DOCKET NOS. 50-266 AND 50-301
ADDITIONAL RESPONSE TO NRC
GENERIC LETTER NO. 81-14
POINT BEACH NUCLEAR PLANT, UNITS 1 AND 2

ATTACHMENT 1
WISCONSIN ELECTRIC'S APRIL 1982 RESPONSE
TO NRC GENERIC LETTER 81-14

SEISMIC QUALIFICATION OF THE
PBNP AUXILIARY FEEDWATER SYSTEM

Figure 2

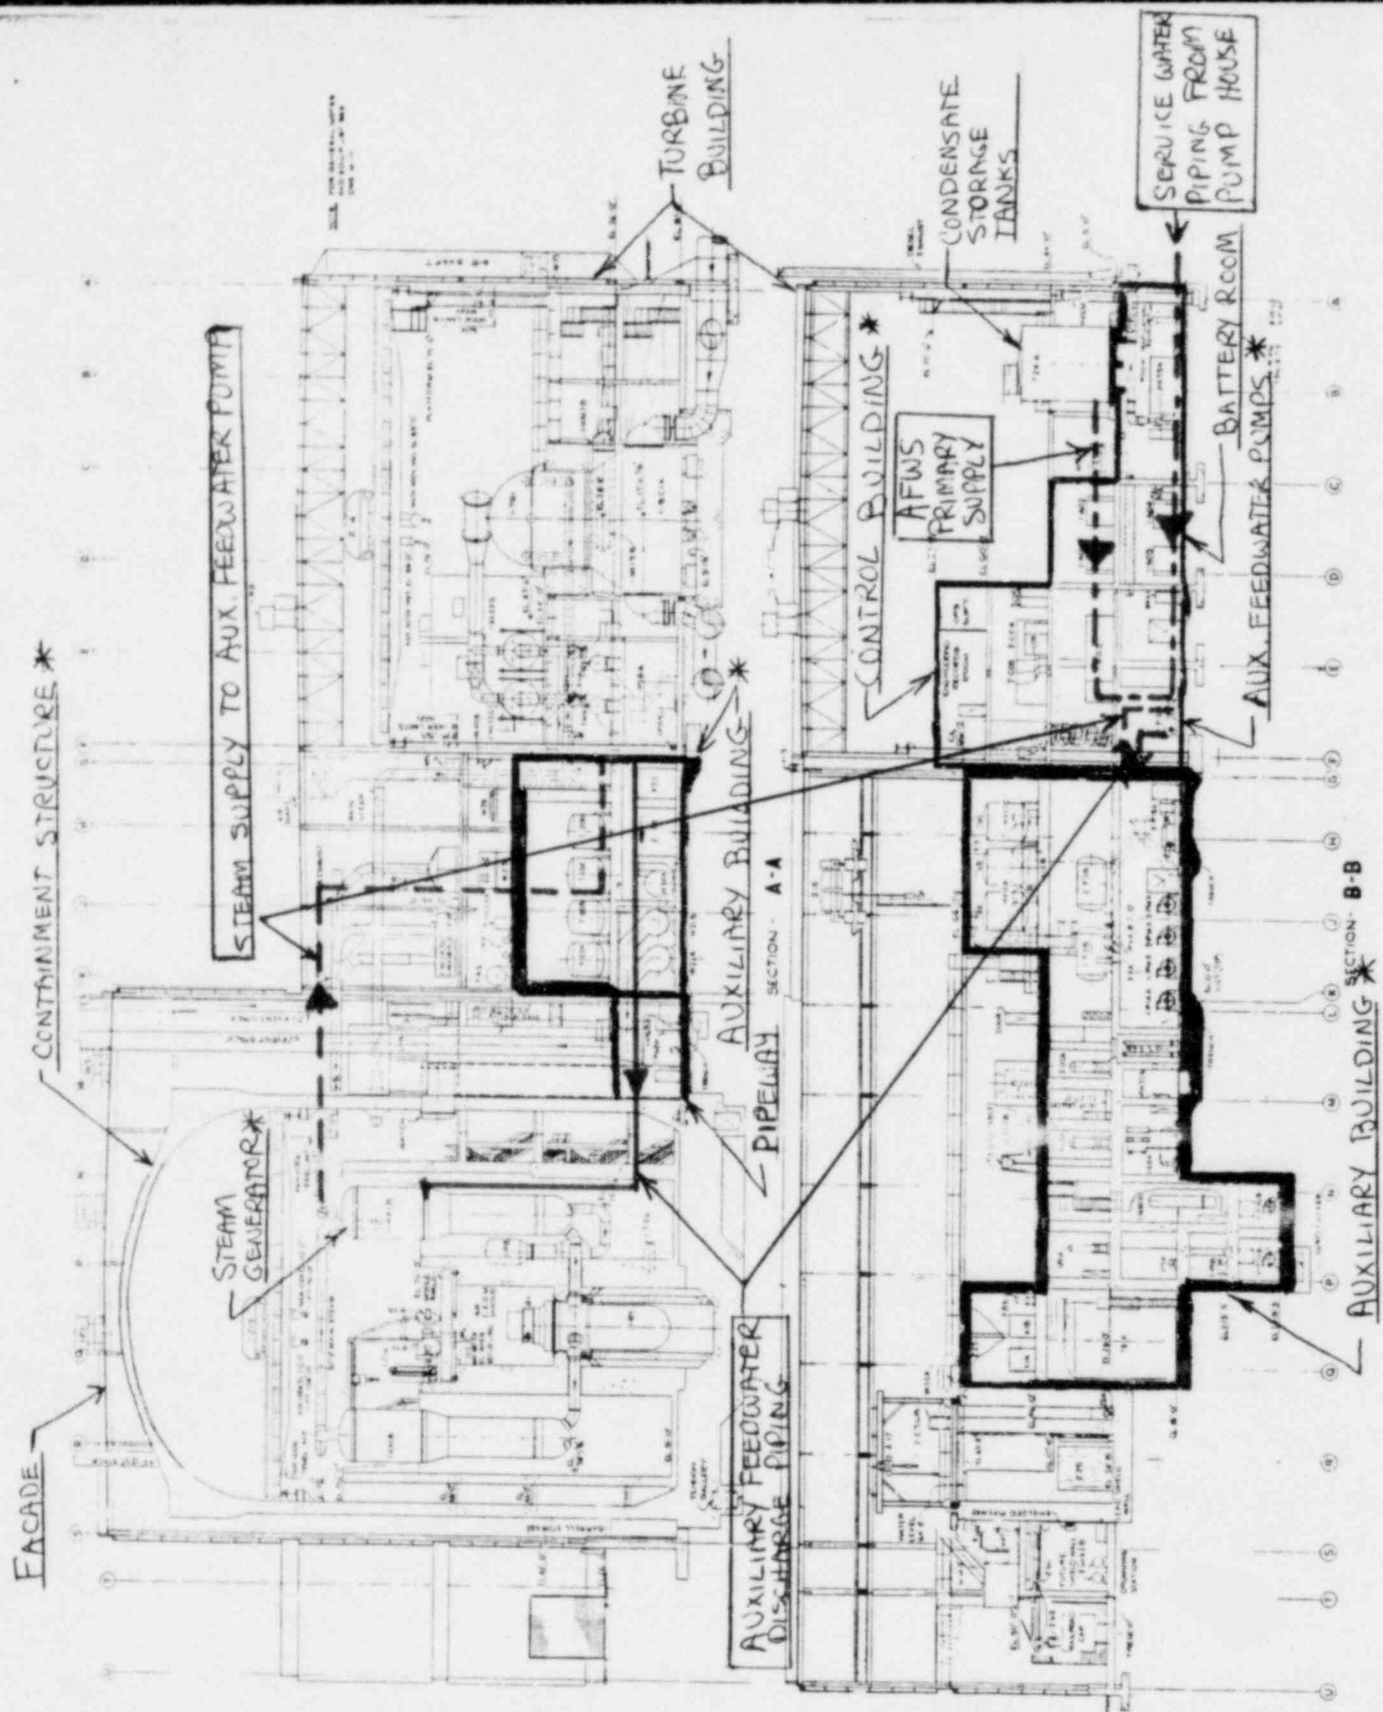
Provide a schematic sketch of the AFW system from suction to discharge which indicates the seismic qualification of the boundaries and items of the AFW system, as specified in Enclosure 1 to Generic Letter 81-14.

Figure 2 schematically shows the relationship of the AFWS piping to the plant structures and the major items of equipment. The figure shows both sources of pump suction water (primary source from the condensate storage tanks with backup from the service water system), the discharge piping into containment, and the steam supply piping to the AFW turbine-driven pumps. As indicated by Figure 2, most of the piping is located within seismically designed structures. A portion of the service water piping is underground and inaccessible, a portion of the AFW pump

The structural boundaries considered for the AFWS have been indicated in Figures 1 and 2 and Table 1. The Turbine Building, the Facade structure, and the superstructure of the Auxiliary Building were not designed as seismic structures.

Figure 4

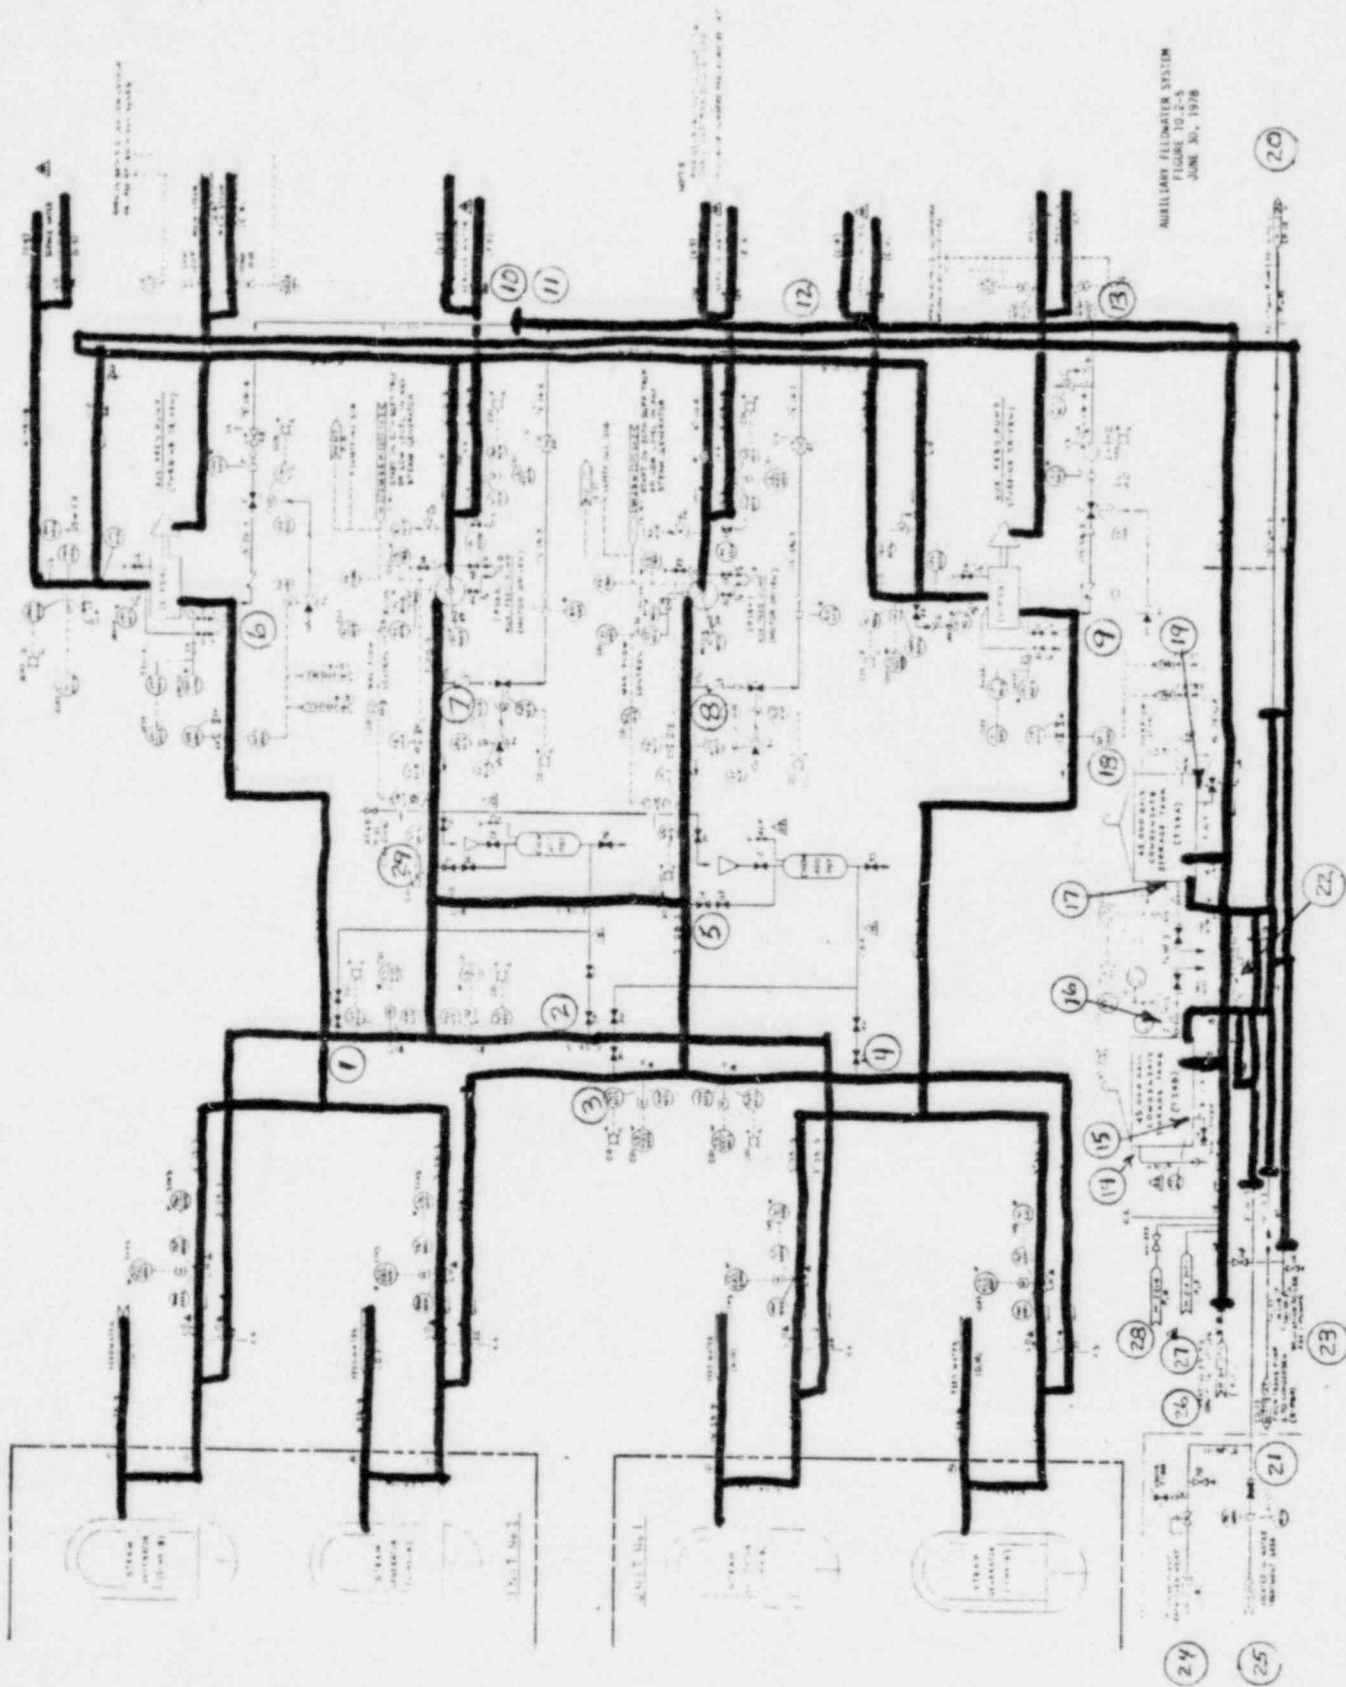
Verify that all such considerations were applied to your evaluation and that all the indicated items and boundaries to assure system function are Seismic Category I and designed to resist the SSE specified for the plant.

- a. Pipe connections 1 through 5 and 29 are small diameter piping for chemical addition pots. These have two manual, normally closed valves and were recently inspected.

- b. Pipe connections 6 through 9 are the outlet connections for the pump recirculation piping. These connections were recently inspected. The recirculation valve is shown on the drawing as normally closed. However, following a recent modification these recirculation valves are normally open. These valves close, as before, upon receipt of a pump discharge flow signal. Thus, the overall operation of the system has not changed significantly.

- c. Pipe connections 10 through 13 were not inspected but are connected to piping included in the IE Bulletin 79-14 program (isometric P-159).
- d. Connections 14 through 19 are overflow, drain, and instrument connections on the CST.

- e. Connections 20 and 21 go to the Unit 1 and 2 Condensers through a single air-operated valve (2122A) which is normally closed. These pipelines were not originally required to be seismic (nor was the condenser). A portion of this branch piping has structurally been included in the IE Bulletin 79-14 program (isometric P-118). While the Unit 1 piping is fully shown on isometric P-118, the analytical model terminated at support H-43, drawing zone C-3.

- f. Connection 22 is a 1.5 inch connection to the Waste and Blowdown Evaporator Distillate Processing System. This piping was not required to be seismically designed, has many branch connections, and normally shut manual valves.

- g. Connection 23 is a 4-inch connection to the heating boiler feed pump through a normally open valve and a check valve that prevents flow from the CST. The IE Bulletin 79-14 program (isometric P-118) included the piping through the manual valve but not through the check valve. This piping was not originally required to be seismic.

- h. Connection 24 is a 2-inch diameter connection that provides a source of water to the turbine plant chemical addition tanks through normally closed valves close to the tanks. This piping was not originally required to be seismic.

- i. Connection 25 is a 3-inch diameter connection to the mixed bed demineralizer in the makeup water treatment system through a closed valve. This piping was not originally required to be seismic.

- j. Connections 24 and 25 are shown with check valves to prevent flow from the CST's. However, the discs have been removed from these valves in order to provide water supply to the turbine plant chemical addition system. Manual isolation valves are provided. This piping was not originally required to be seismic.

- k. Connections 26, 27 and 28 are protected by check valve 118 which was included in the IE Bulletin 79-14 program (isometric P-159). These connections are protected by a check valve (on drawing M-214) to prevent flow from the CST's. This piping was not originally required to be seismic.

Figure 3 is a reduced copy of Figure 10.2-5 of the FFDSAR and is the principle piping diagram for the AFWS. Figure 4 is a copy of Figure 3 marked to identify the piping which was considered during the evaluation of IE Bulletin 79-14. These lines are numerically marked to aid in the following discussion of piping connection boundaries.

The piping branch connections considered do not correspond to the NRC's boundary definition because most of the connections do not have a second normally closed valve nor were the connections required to be seismically designed when the plant was licensed. The foregoing discussion, in combination with the figures, identifies the existing plant configuration and define what has been considered.
